TECHNICAL BULLETIN

[Issue No.] GOT-A-0163

[Title] Change to the Country of Origin Statement for GOT Cables

[Relevant Models] GOT2000 Series, GOT1000 Series

3. Example of the change to the statement

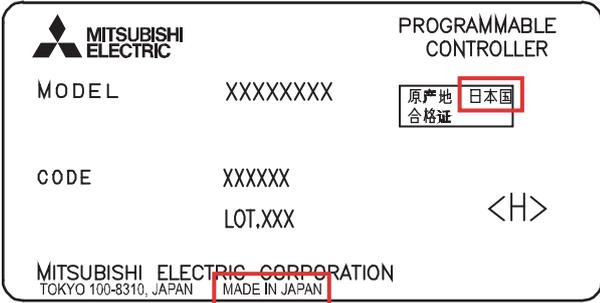
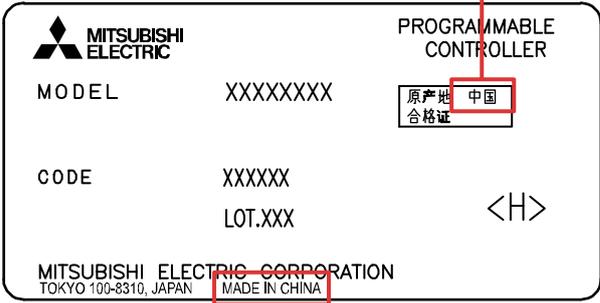
The following shows the example of the change to the statement on the rating plate.

Before	After
 <p>The rating plate shows the Mitsubishi Electric logo, 'PROGRAMMABLE CONTROLLER', 'MODEL XXXXXXXX', 'CODE XXXXXX', 'LOT.XXX', and '<H>'. The origin statement '原产地 日本国' (Origin: Japan) is highlighted with a red box. At the bottom, 'MITSUBISHI ELECTRIC CORPORATION' and 'TOKYO 100-8310, JAPAN' are listed, with 'MADE IN JAPAN' highlighted in red.</p>	<p>The country of origin statement will be changed to "CHINA".</p>  <p>The rating plate is identical to the 'Before' version, but the origin statement '原产地 中国' (Origin: China) is highlighted with a red box. At the bottom, 'MADE IN CHINA' is highlighted in red. A red arrow points from the text above to the '中国' (China) in the origin statement.</p> <p>"MADE IN CHINA"</p>
